NOTICE OF MEETING
PLANNING AND ZONING COMMISSION
6:00 P.M. – July 16, 2020

PLANNING AND ZONING COMMISSION ITEM:
PC-20-08
FINAL PLAT
4S RANCH, UNIT 7C

SUBJECT: 4S Ranch, Unit 7C Final Plat Acceptance
 PC-20-08

REVIEW MEMORANDUM

SUBDIVISION PLAT OF 4S RANCH, UNIT 8A

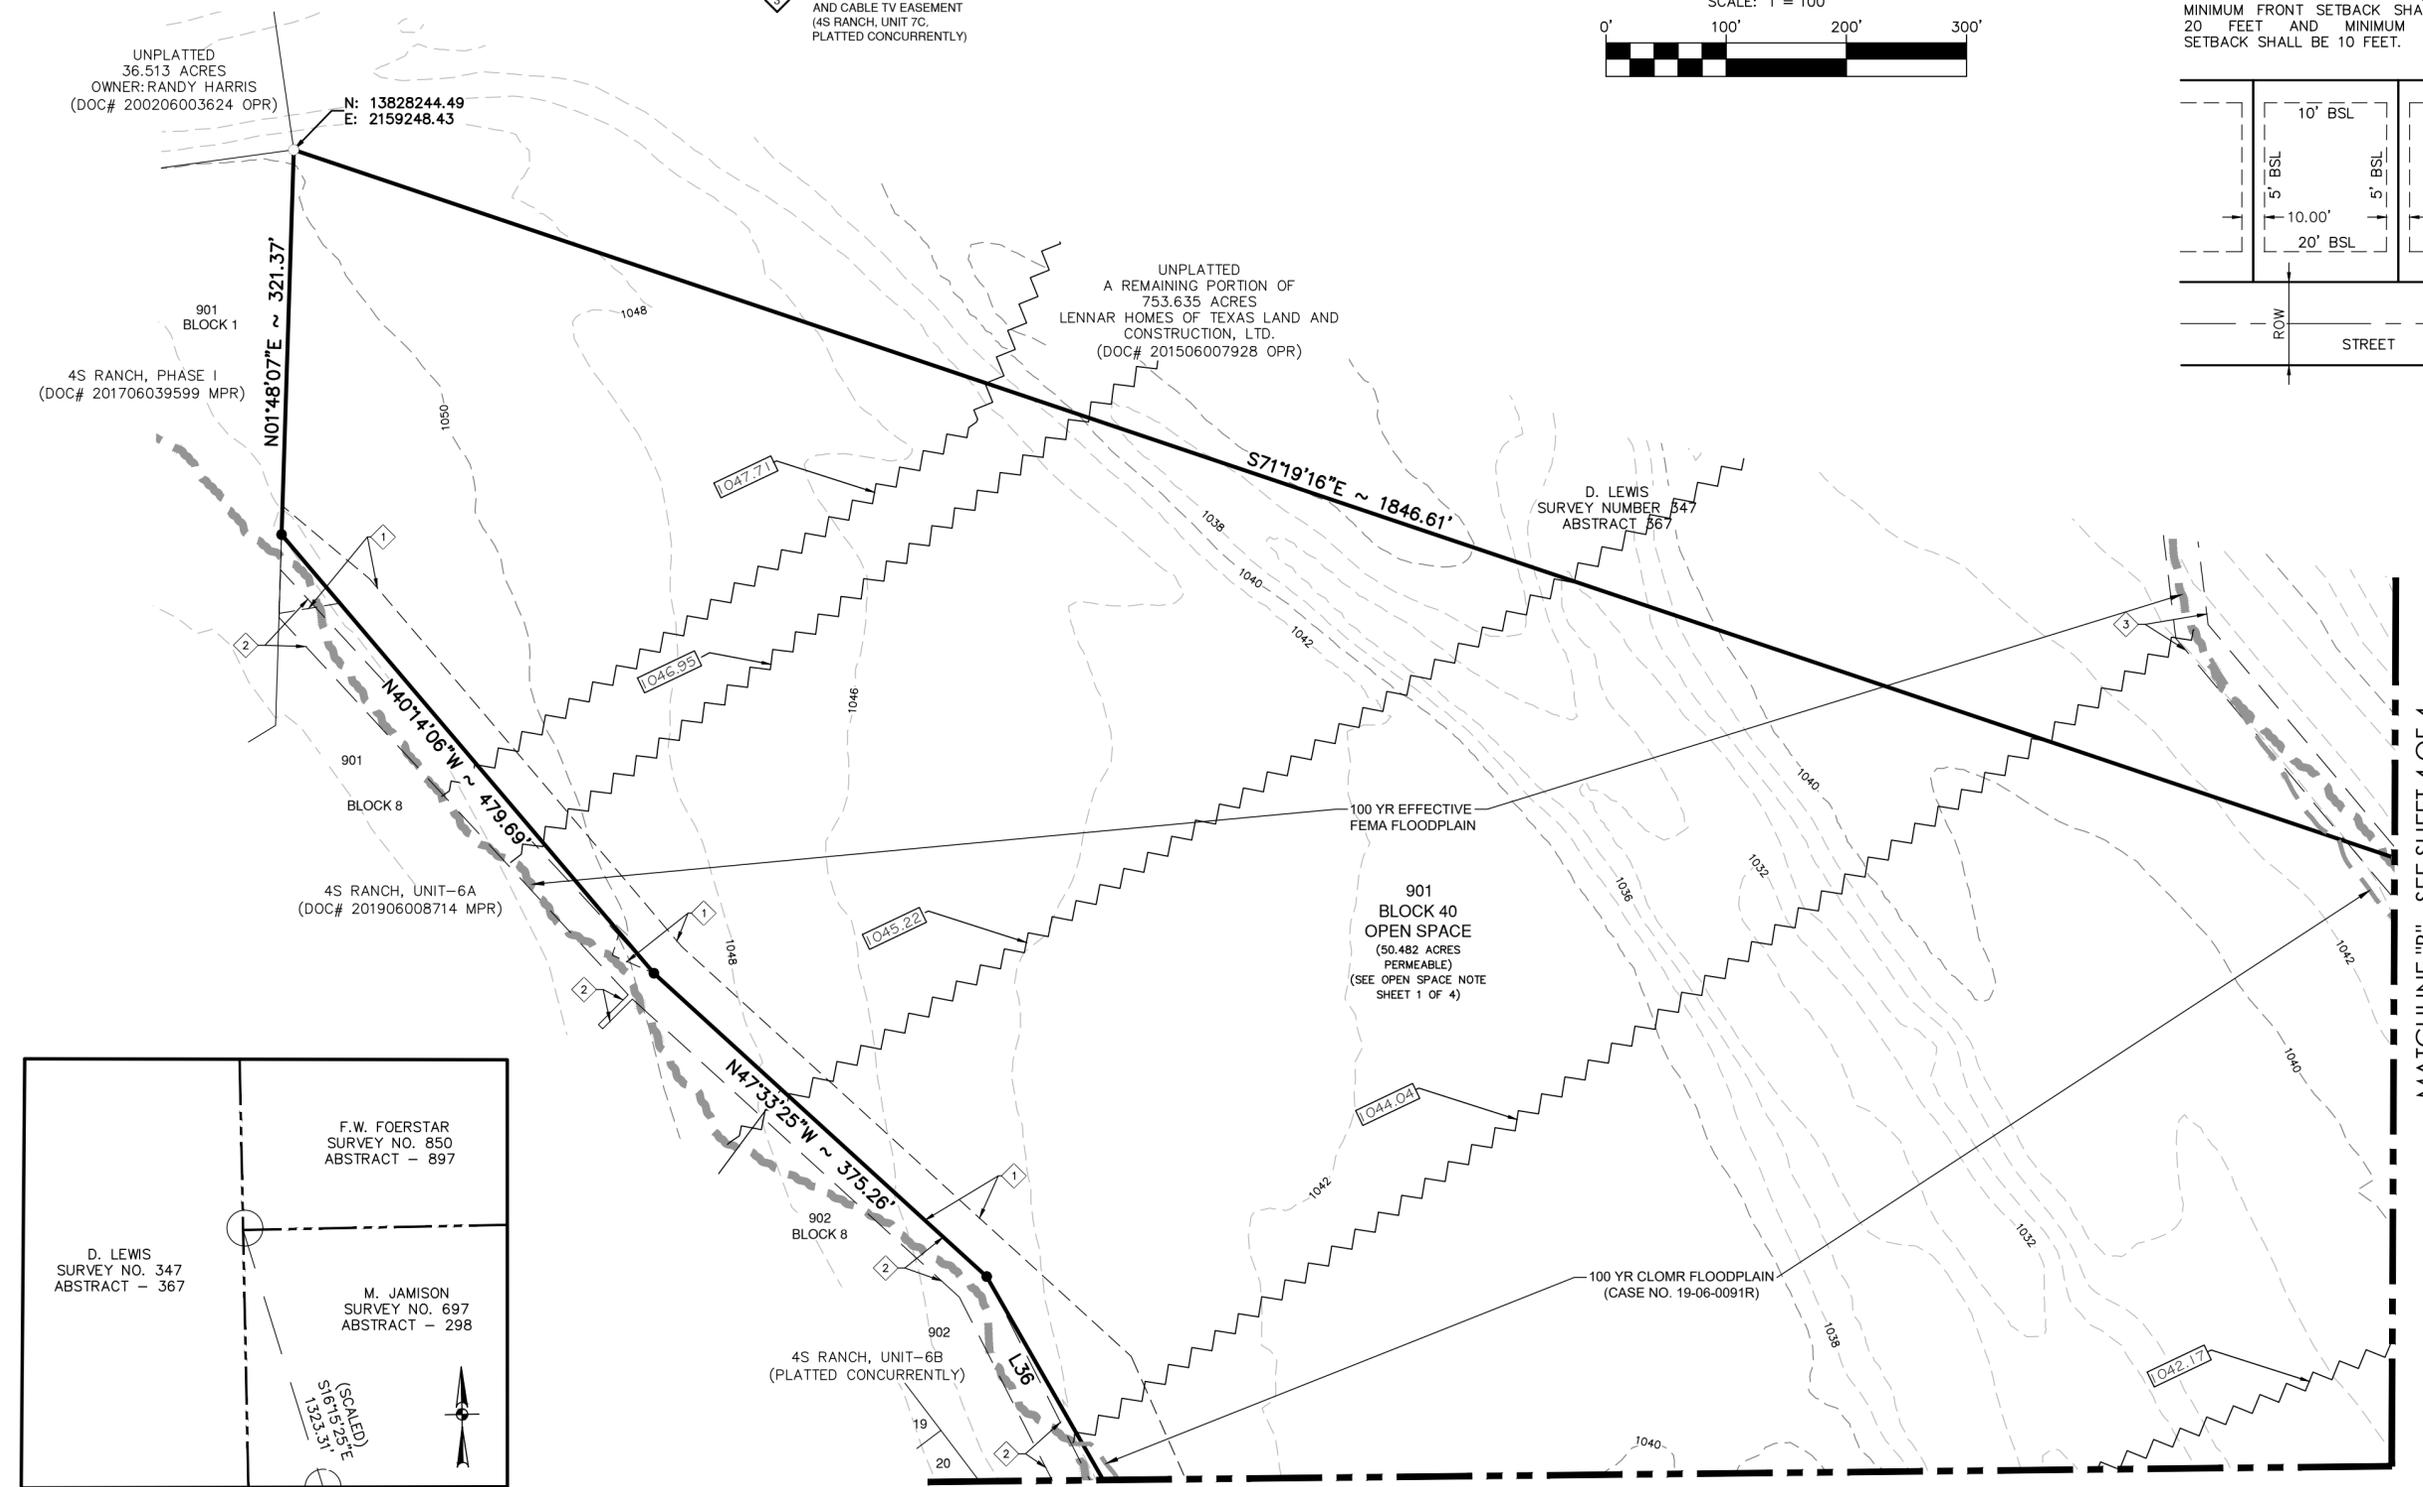
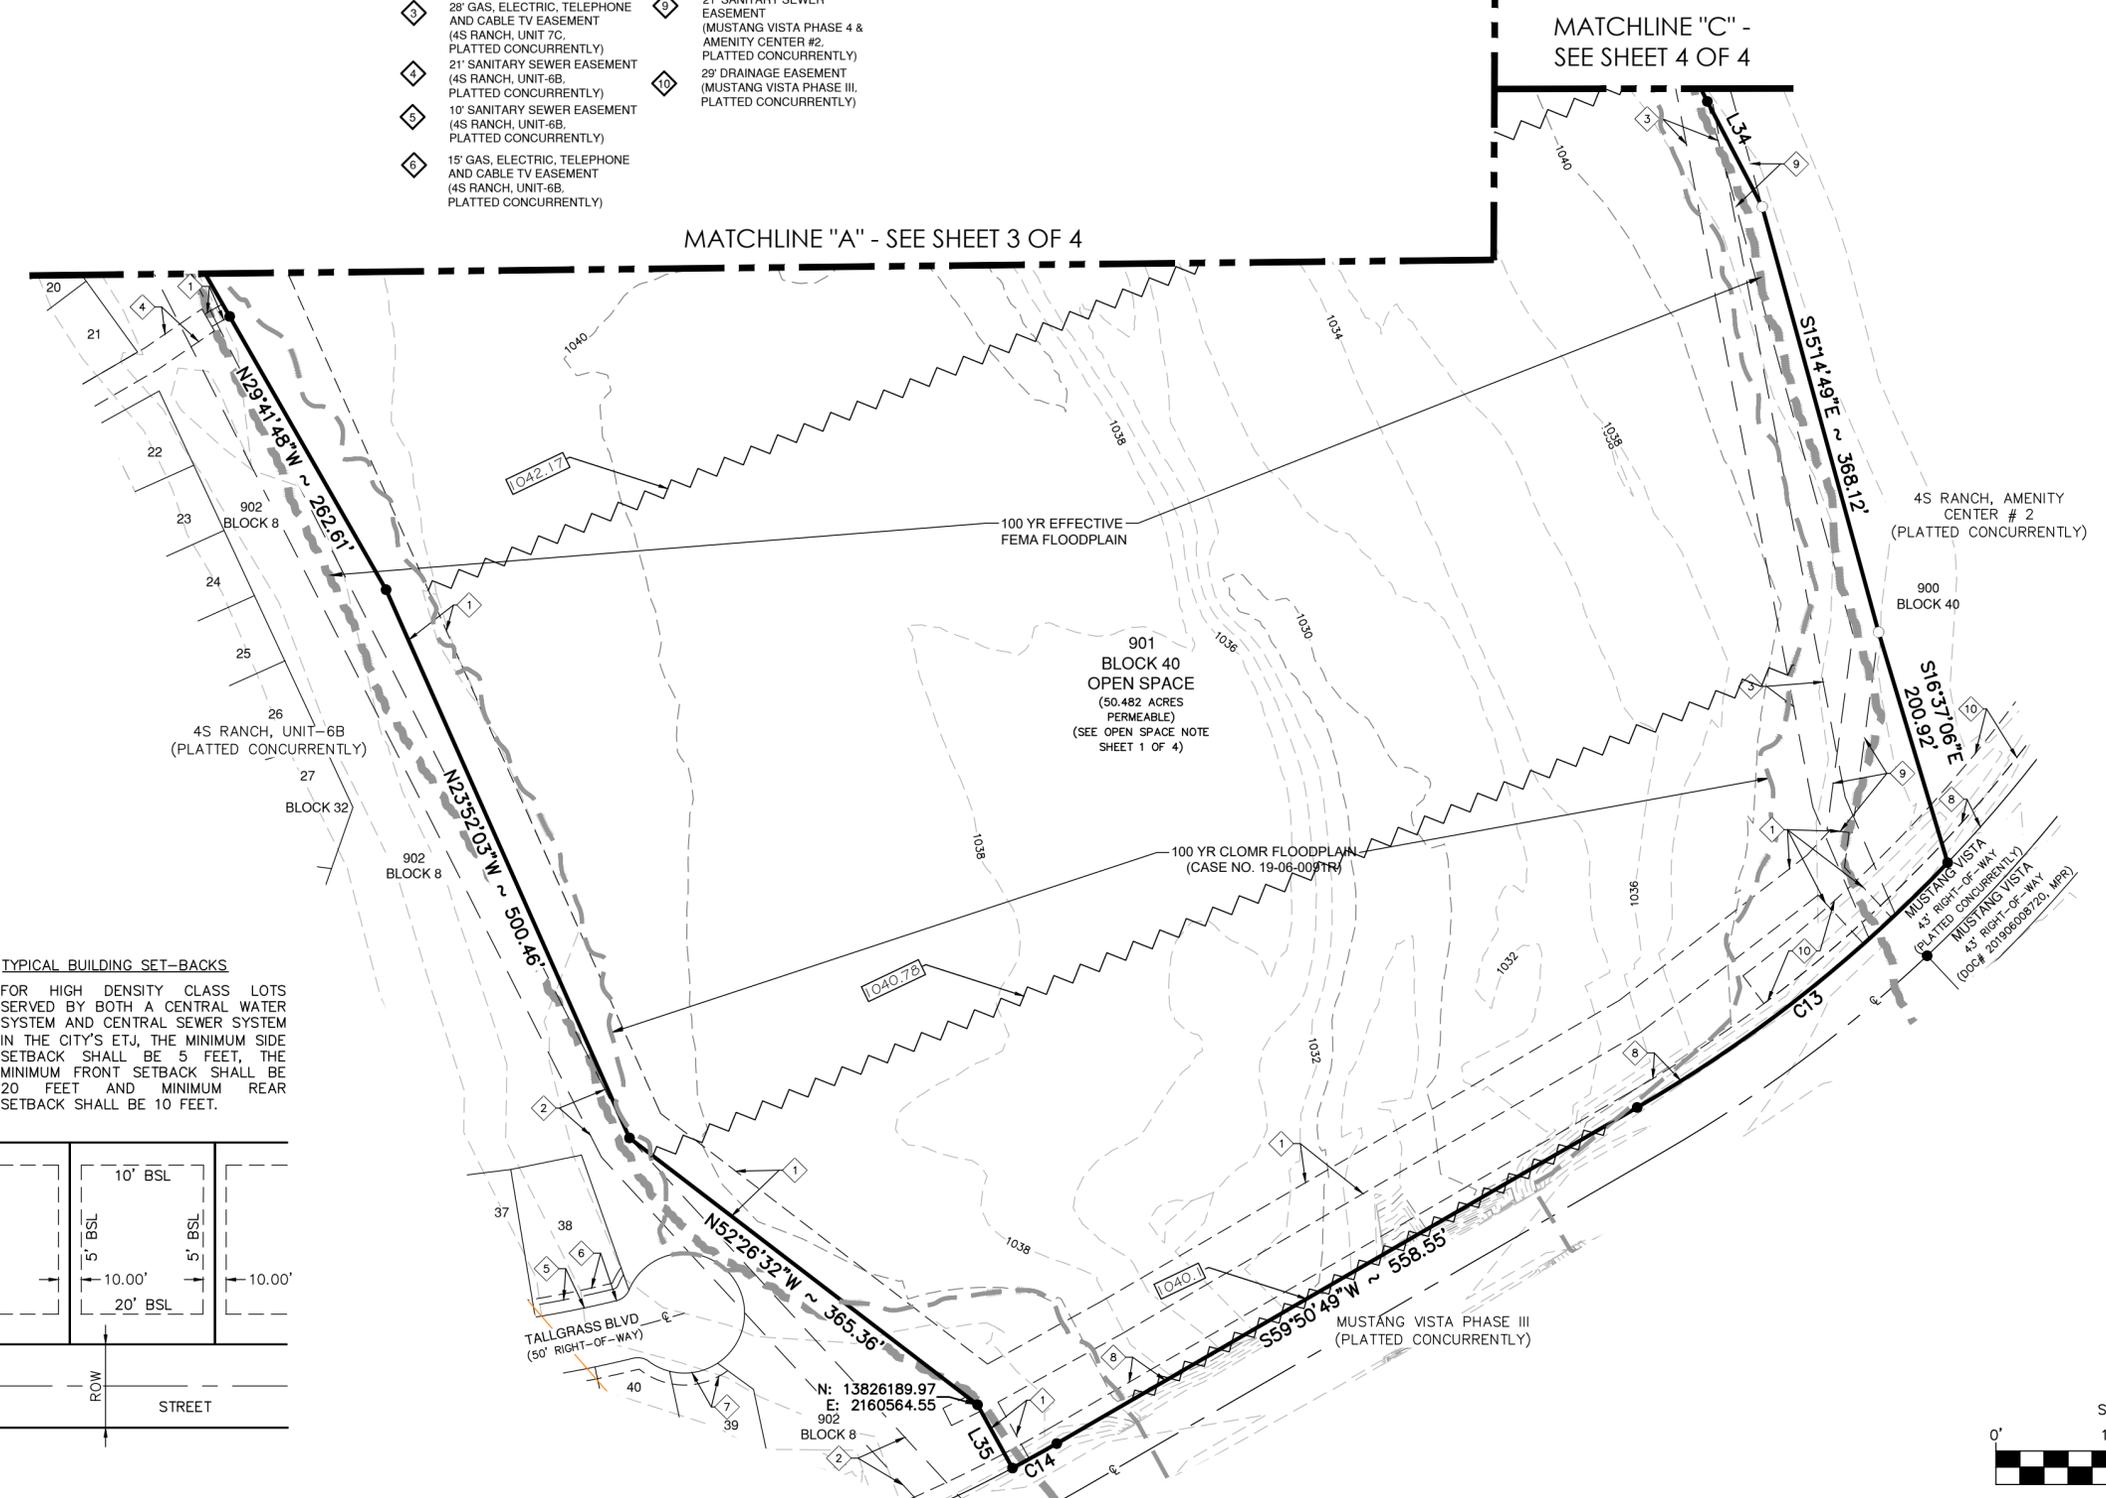
1. Legend on several sheets indicates “platted concurrently” for several easements in various units.
Unit 6B final plat was recommended for approval on November 22, 2019
Mustang Vista Phase 3 final plat was recommended for approval on June 28, 2019
Please provide Doc #'s for all recorded plats – [Comment withdrawn...although already accepted by P&Z, the Mustang Vista Phase III plat has not yet been recorded. No document number is available and the 'PLATTED CONCURRENTLY' text is still appropriate.](#)
